URBAN DESIGN COMMITTEE STAFF MEMO

APPLICATION NUMBER Urban Design Record #UDR25105

ADDRESS/LOCATION Bison Witches Sidewalk Café

HEARING DATE November 04, 2025

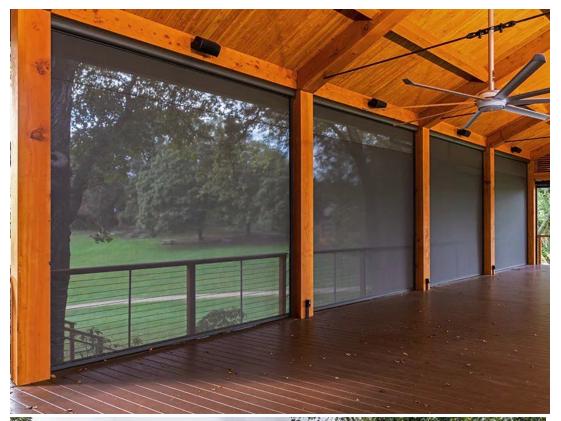
The Committee previously reviewed updated concepts for the Bison Witches sidewalk café enclosure at Tower Square. The proposal aimed to replace the existing red enclosure with a more transparent, retractable system featuring clear motorized curtains and a low floating wall along the existing handrails. The discussion focused on aesthetics, transparency, material alignment with the public plaza, and the structural elements of the cafe, with an expectation that the design team would return at a later date to present the choice of blinds or shades above the proposed low-height wall.

Overall, members appreciated the improved visibility and adaptability of the proposed design through the transparent storefront doors and windows, and roll-down clear phantom screens, while noting that color, texture, and material details would benefit from further refinement.

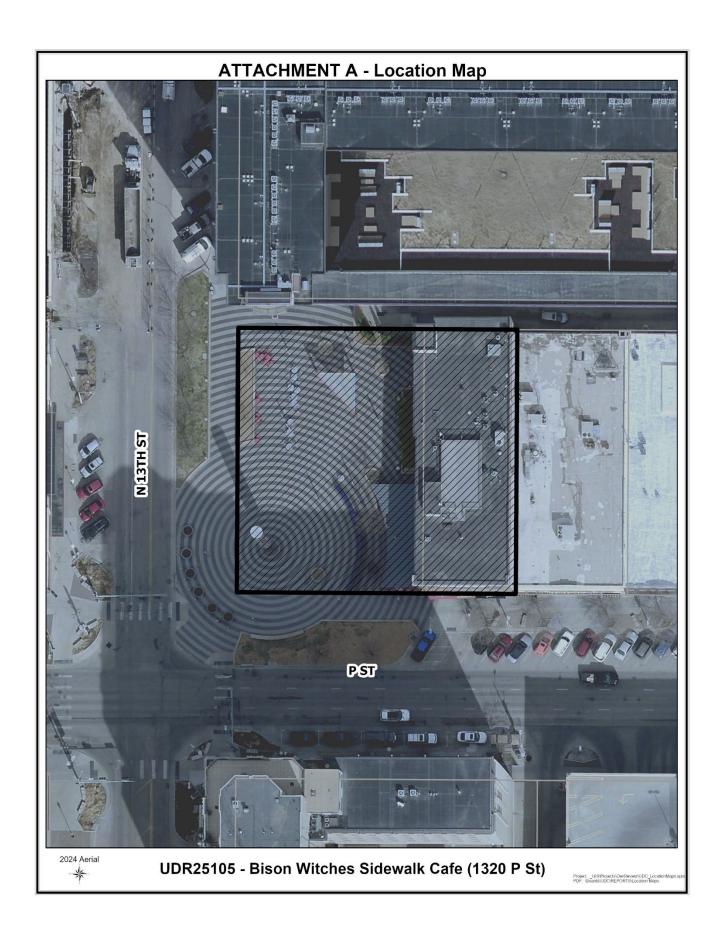
Through correspondence with staff, the applicant has conveyed that the screens will be motorized and would be down only when the temperature is below 60 degrees, or in other extreme conditions. Precedent images of a shade with 3% openness:

The City's current code does not address shades, and shades such as these have not been previously approved for sidewalk cafés. However, as part of our ongoing update to the Sidewalk Café Code and our effort towards new Sidewalk Café Design Standards, we are recommending a minimum openness factor of 10–14% or above to ensure visual https://linclanc.sharepoint.com/sites/PlanningDept-Boards/Shared Documents/Boards/UDC/Agendas/2025/Nov 4 Web PDF's/Bison Witches SIdewalk Cafe Staff Report_item2.docx

The applicant's engineer has noted that increasing to 15% openness would require an interior insect net, which would effectively reduce transparency again.

Staff requests that the UDC review the shade samples and provide advisory input on whether a 10% openness factor achieves an acceptable level of transparency and visual quality for this site.
